St. Tammany Parish Communications District 9-1-1 Dispatch Center
BID NO.: NF-2016-06-16
GLA Project No. 14109

ADDENDUM NO. 3

Date: 03 August 2016

1 Fire Suppression Plan - [FM-200]/Inert Gas (Partial Plan)
1/16" = 1'-0"

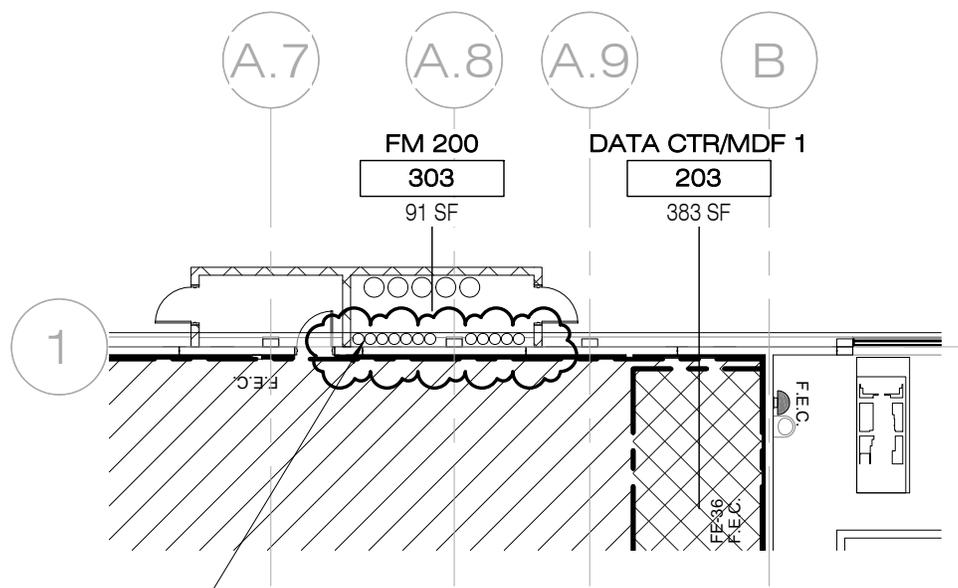
- 2.7 **Sheet a002, Keynote 1:** Revise keynote to read as follows: *"PROVIDE INERT GAS FIRE SUPPRESSION SYSTEM AT RAISED FLOOR VOLUME (15,030 CU. FT. - VERIFY) AT 911 DISPATCH [200] AND TRAINING ROOM [201]"*

- 2.8 **Sheet a002:** Revise sheet legend entitled **"[FM-200] NOTES"** as shown on attached sketch **SK 03**
- 2.9 **Sheet a002:** locate inert-gas fire suppression cylinder tanks within Room [303] as shown on attached sketch **SK 03**.

- TOTAL VOLUME COVERED BY INERT GAS:
15,030 CU.FT. [RM200] + [RM201] (UNDERFLOOR VOLUME)
- INSTALL PER NFPA 2001

INERT GAS FIRE SUPPRESSION CANISTERS AND CONTROL SYSTEM - RACK CANISTERS TO WALLS. QUANTITIES TO BE CALCULATED BY FIRE SUPPRESSION SYSTEM PROVIDER.

SK 06

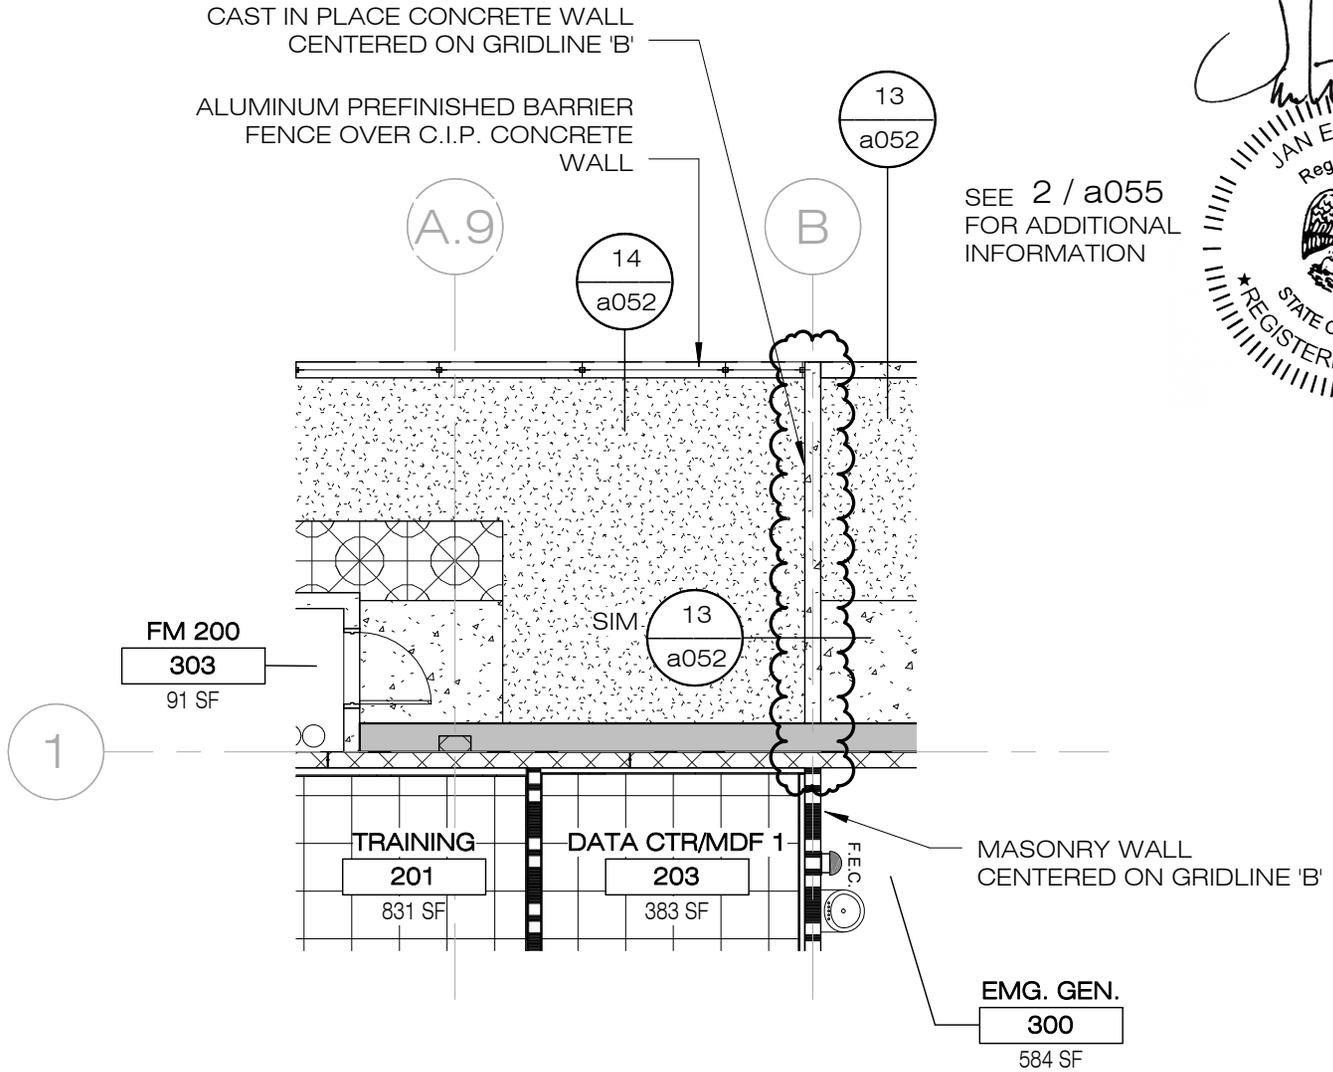
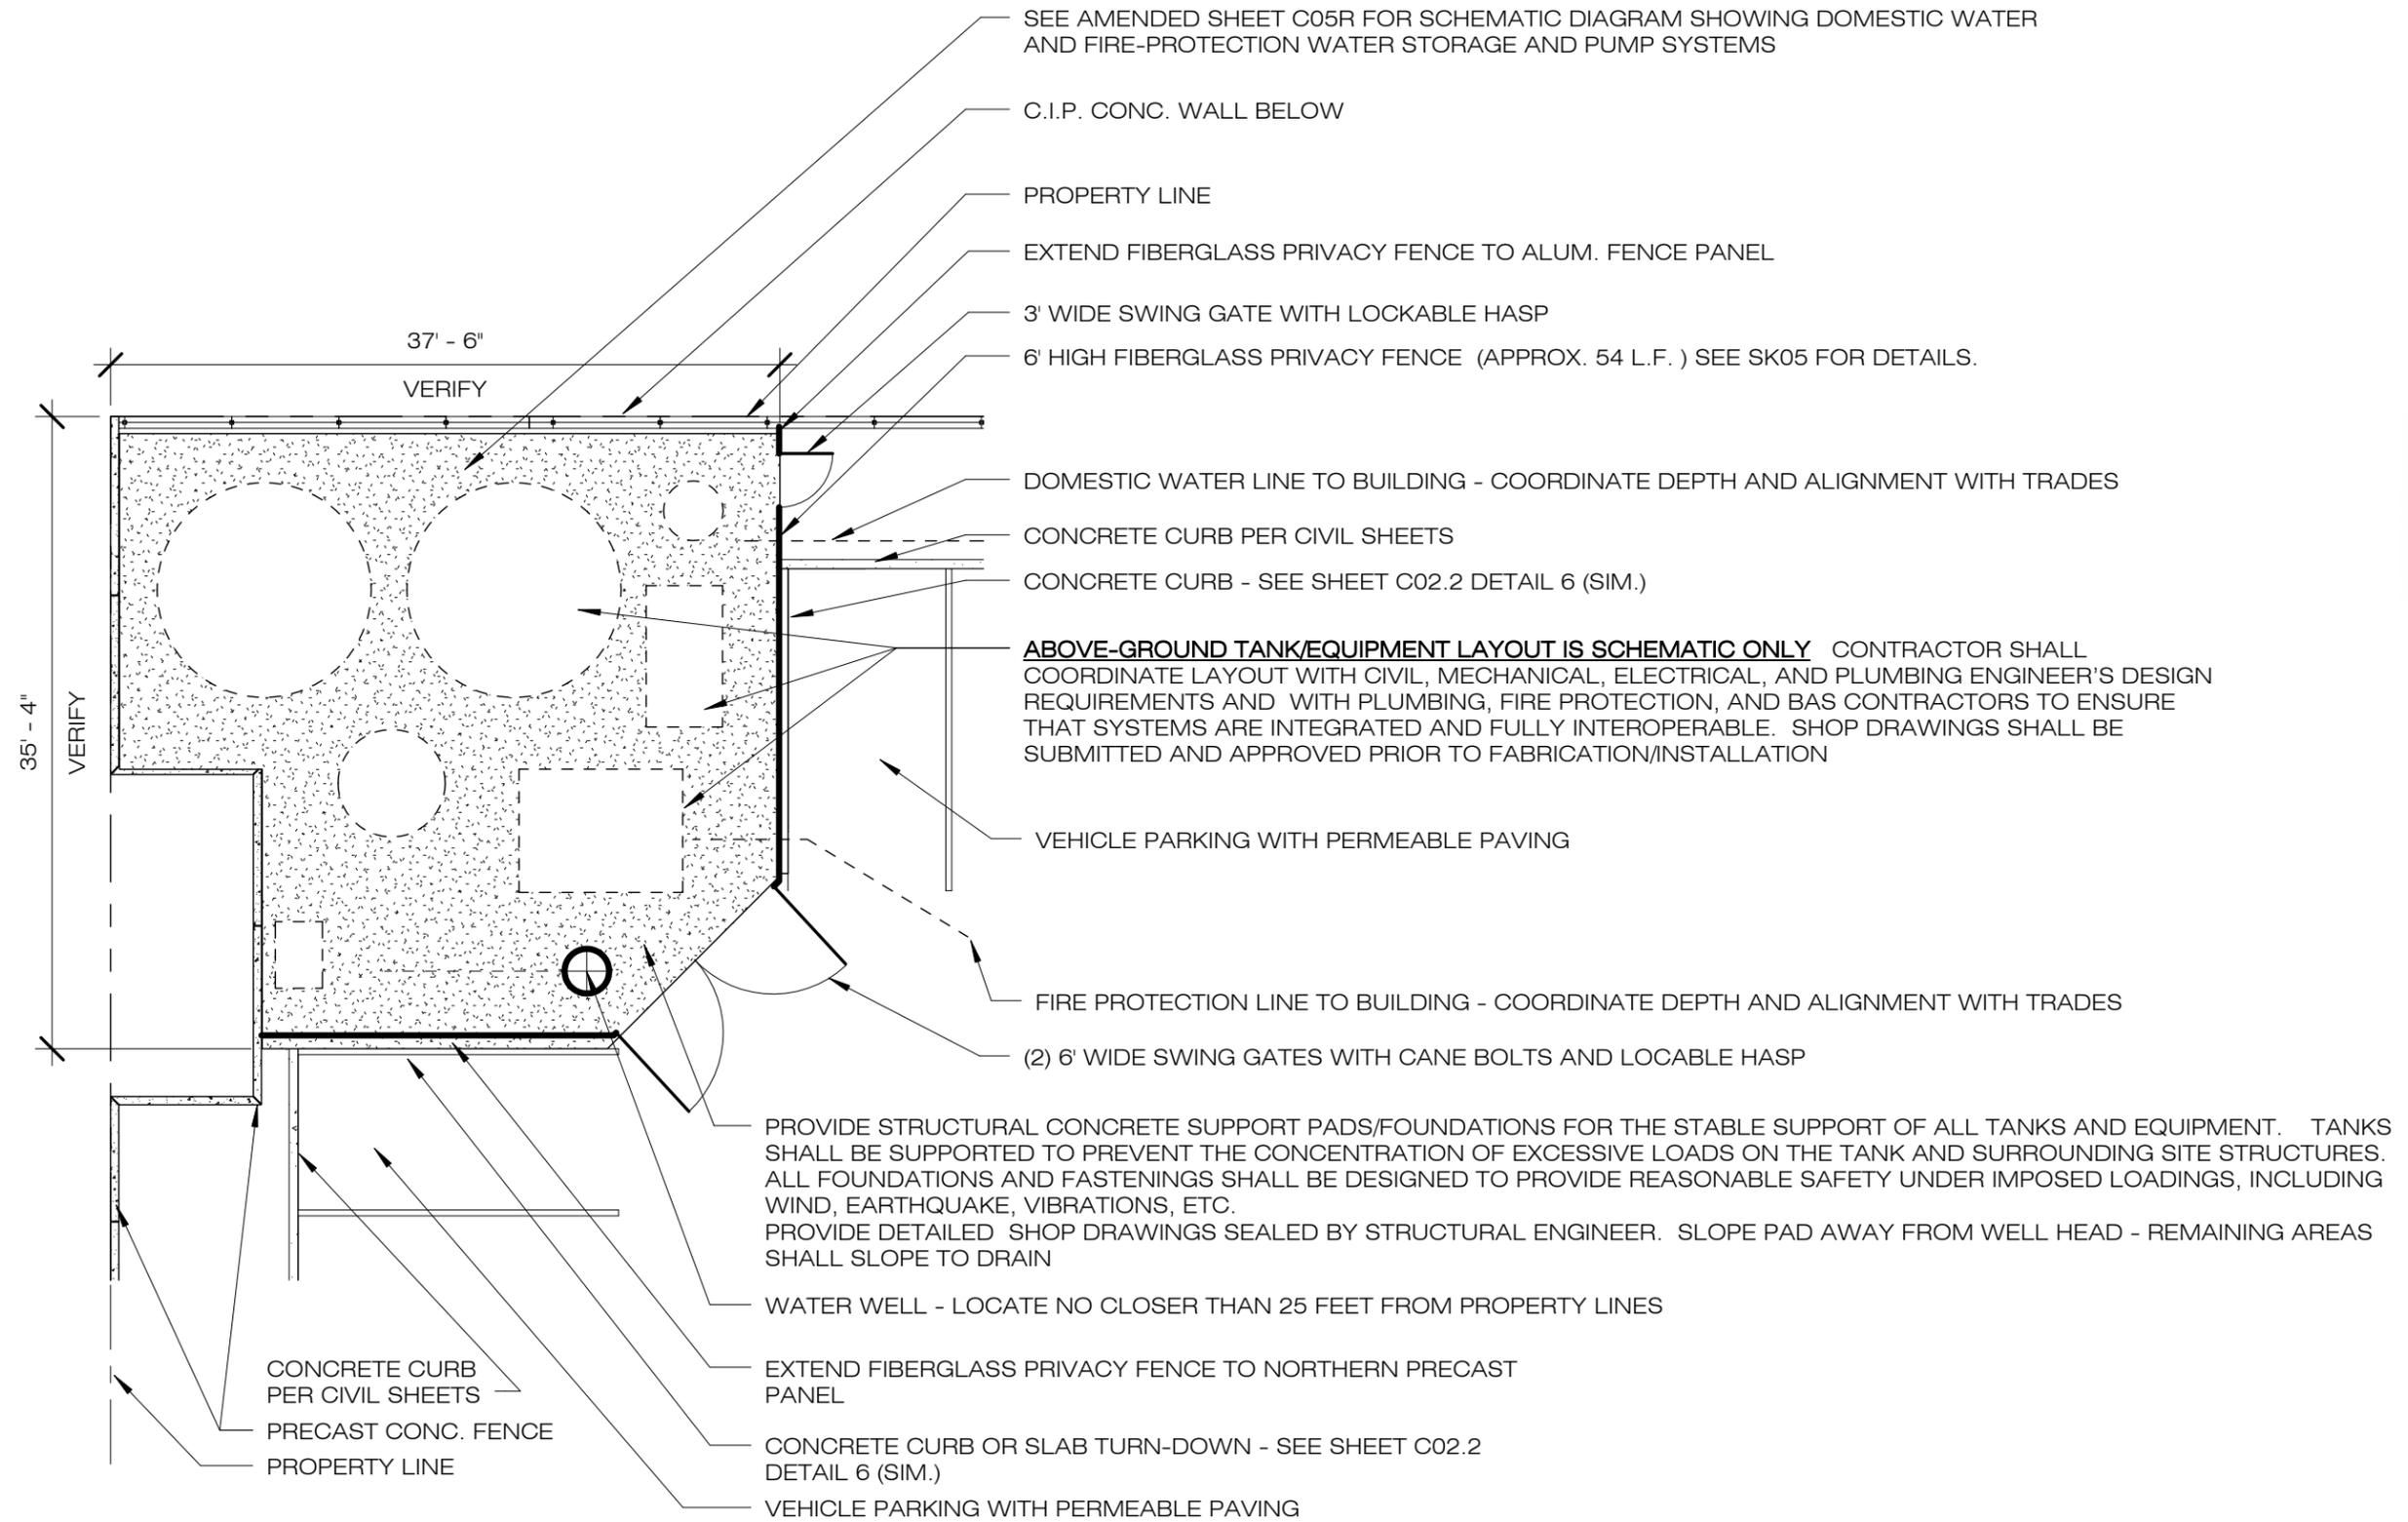
- 2.11 **Sheet a050:** Located pre-cast concrete wall as shown on attached sketch **SK 06**.
- 2.12 **Sheet a051:** Provide screening fence at water-well as shown on attached sketch **SK 04** and **SK 05**.

CAST IN PLACE CONCRETE WALL
CENTERED ON GRIDLINE 'B'

ALUMINUM PREFINISHED BARRIER
FENCE OVER C.I.P. CONCRETE
WALL

8 V-track at Rolling Gate
3" = 1'-0"

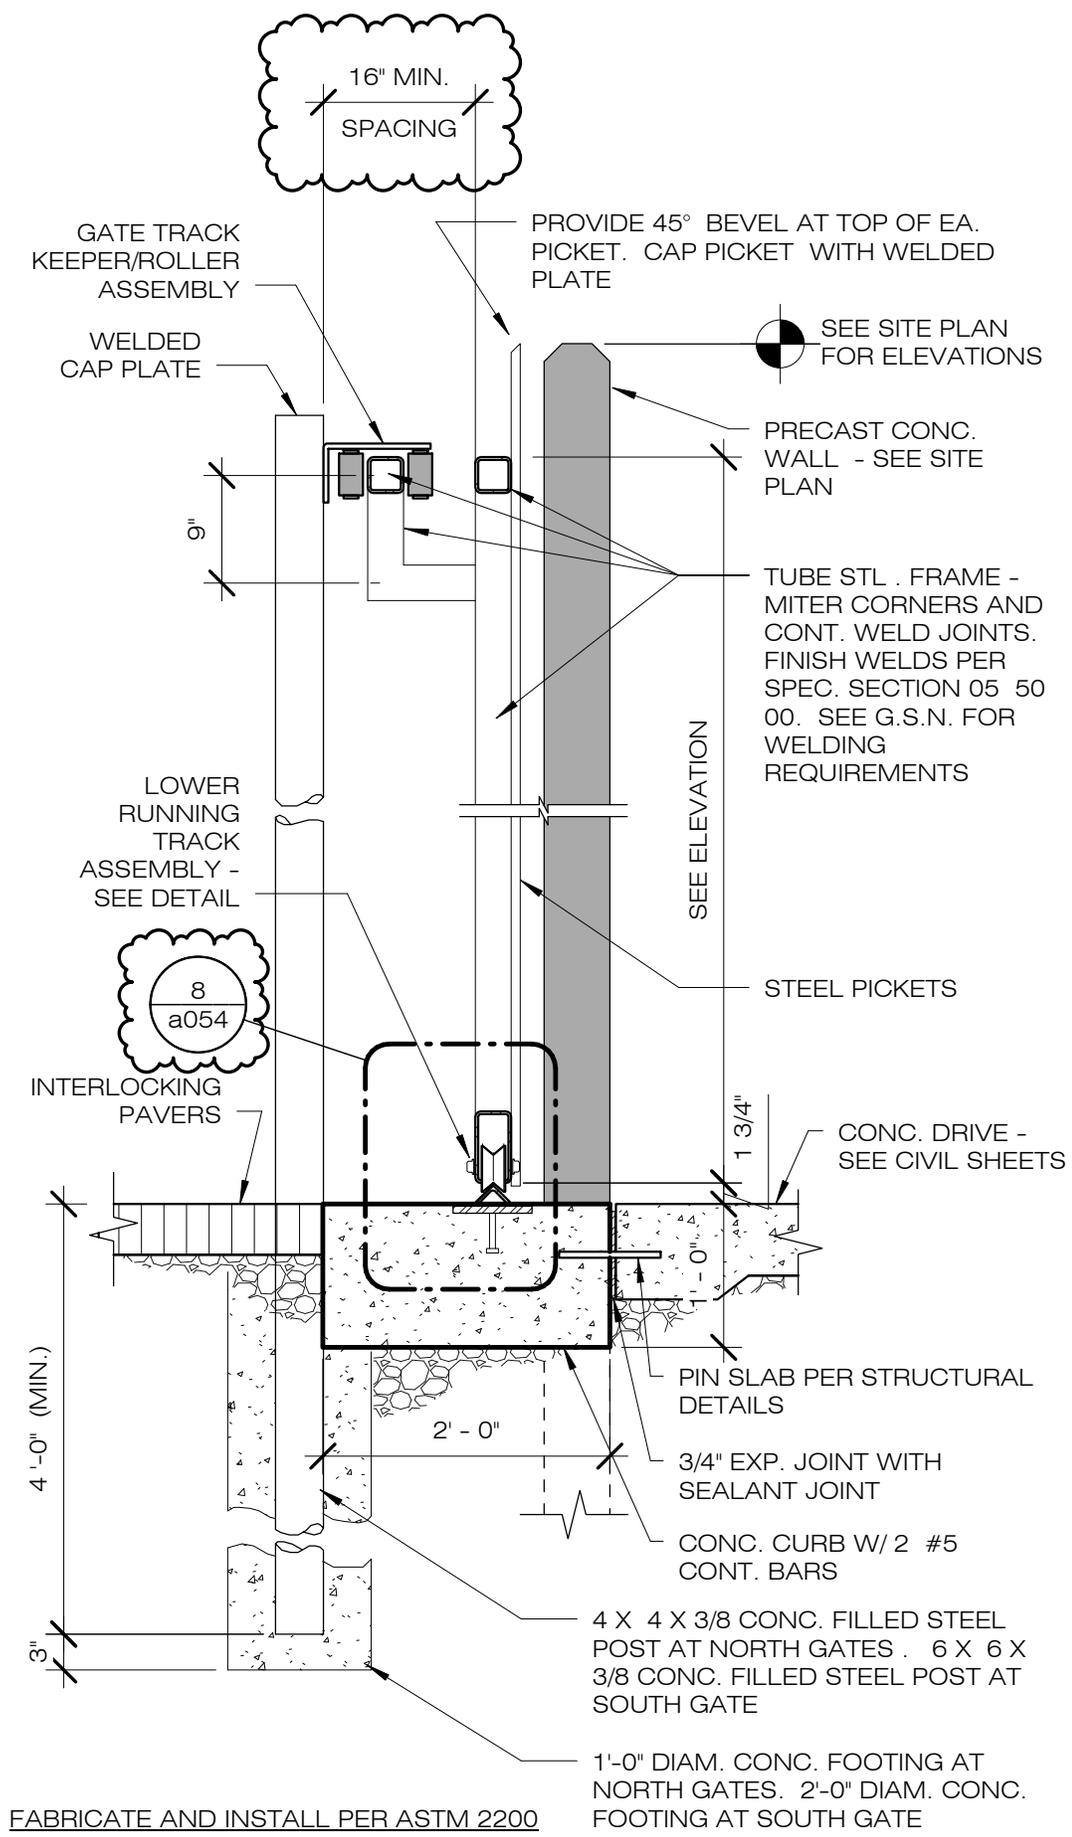
- 2.13 **Sheet a052:** Revise detail number 11 (entitled "Cast-in-Place Wall at Property Line") to detail number 14.
- 2.14 **Sheet a054 Detail 8:** Revise detail as shown on attached sketch **SK 08**.

FABRICATE AND INSTALL PER ASTM 2200

11 Section at Rolling Gate
3/4" = 1'-0"

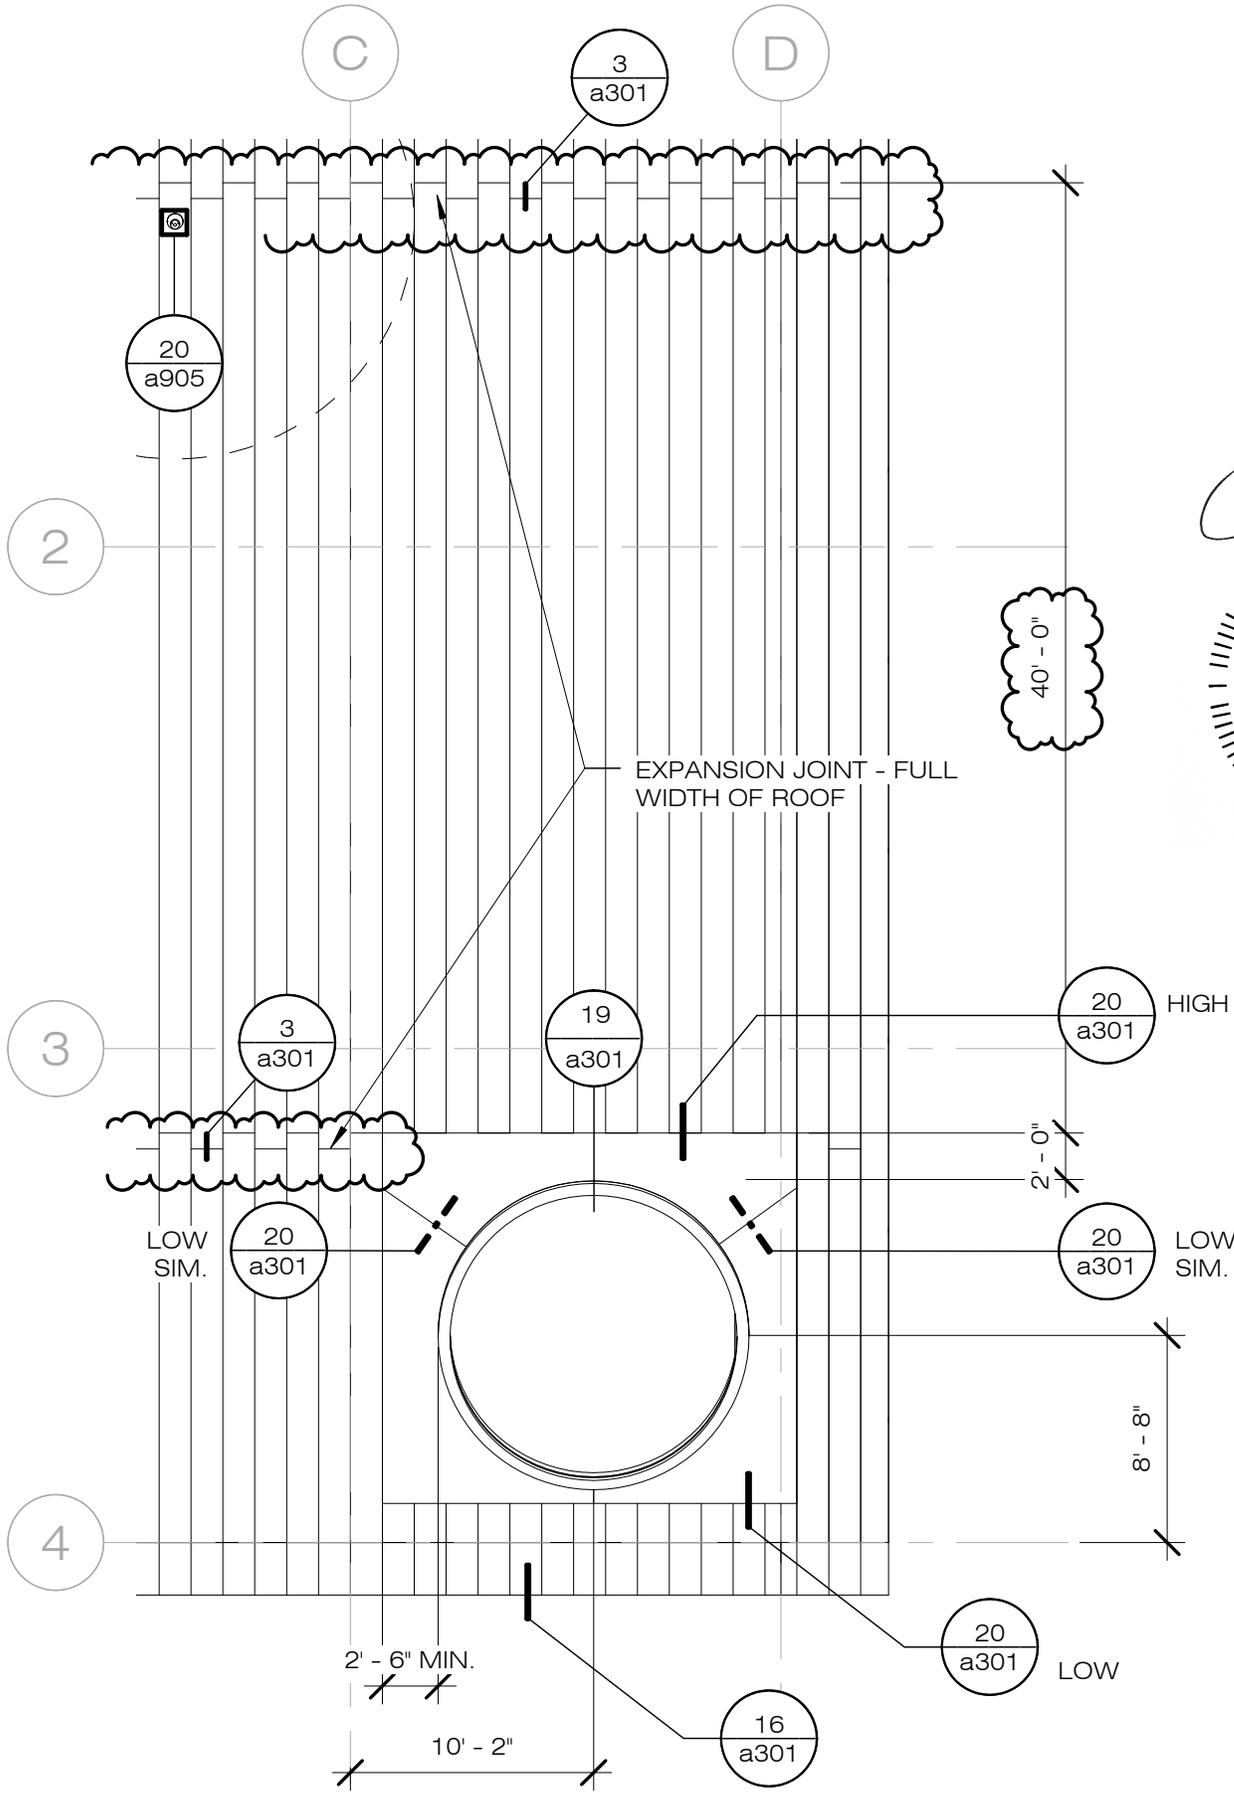
- 2.15 **Sheet a054 Detail 11:** Revise detail as shown on attached sketch **SK 09**.
- 2.16 **Sheet a300 Roof Plan:** Add second line of expansion joints at standing seam metal roof system as shown on attached sketch **SK 07**.
- 2.17 **Sheet a401 Detail 2:** There is no gutter at the lower edge of the roof fascia.
- 2.18 **Sheet a603 Detail 2:** Wall finish above millwork shall be acoustical panel system. Architectural millwork finish shall be wood veneer.
- 2.19 Replace **Sheet C05** with **Sheet C05R** (attached herein).
- 2.20 Provide domestic water booster pump station and domestic above-ground potable water storage tank in accordance with Sheet **SKP-1** (attached).
- 2.21 Finish Selections issued herein reflect the basis of Design. Owner has approved these finishes. Any submitted products must be equal in quality and meet color/texture, maintenance criteria established.

FABRICATE AND INSTALL PER ASTM 2200
